Access Compliance Report

Public Rights-of-Way

Intersection ID: N/A	Main Street: ELGIN_MOOR_RD	Cross Street: LANGWELL_LN	Location: NE
ADA ID: 7A7FC7476FC6	Ramp Type: Perp	Initial Pass/Fail: Fail	Overall Compliance: No
Severity Score: 22.5			
Codes/Mitigation Info/Possible Solution		Field Measurements/Component Compliance

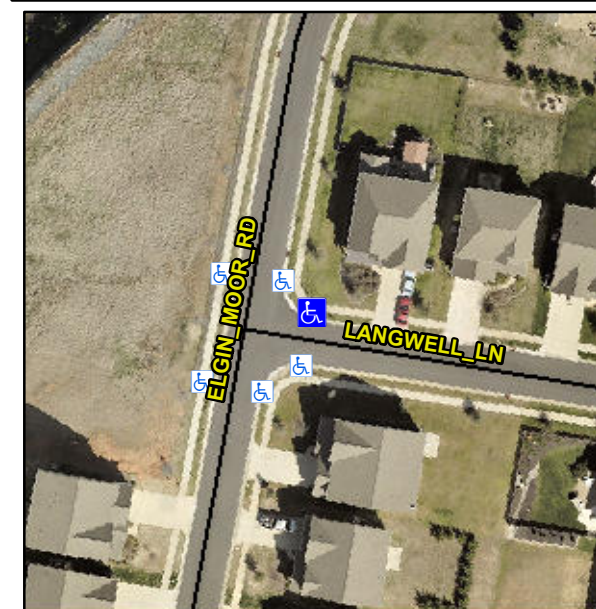
Not Found, R304.5.1, R304.2.2, R304.5.3

Compliance	Description	Data	Compliance	Description	Data
N/A	Ramp Length (in)	47.5	No	Ramp Slope (%)	8.5
No	Ramp Width (in)	47.0	No	Ramp XSlope (%)	2.7
N/A	Flare Type LT	N/A	N/A	Flare Type RT	N/A
N/A	Flare Slope LT (%)	N/A	N/A	Flare Slope RT (%)	N/A
N/A	Flare Traversable LT?	N/A	N/A	Flare Traversable RT?	N/A
N/A	Landing Length (in)	N/A	N/A	DWS Provided?	N/A
N/A	Landing Width (in)	N/A	N/A	DWS Contrast?	N/A
N/A	Landing Slope (%)	N/A	N/A	DWS Length (in)	N/A
N/A	Landing X Slope (%)	N/A	N/A	DWS Full Width?	N/A
N/A	Landing Curb? (Y/N)	N/A	N/A	DWS Offset (in)	N/A
N/A	Shared Landing?	N/A			
N/A	Gutter Ponding?	N/A	N/A	Gutter Slope (%)	N/A
N/A	Gutter Lip Ht (in)	0.5	N/A	Gutter X Slope (%)	N/A
N/A	Painted X Walk1?	No	N/A	Painted X Walk2?	N/A
	X Walk 1 Direction	To SW		X Walk 2 Direction	N/A
N/A	X Walk 1 Width (in)	N/A	N/A	X Walk 2 Width (in)	N/A
	X Walk 1 Slope (%)	1.5		X Walk 2 Slope (%)	N/A
	X Walk 1 X Slope (%)	3.0		X Walk 2 X Slope (%)	N/A

Remove & Replace Entire Ramp.
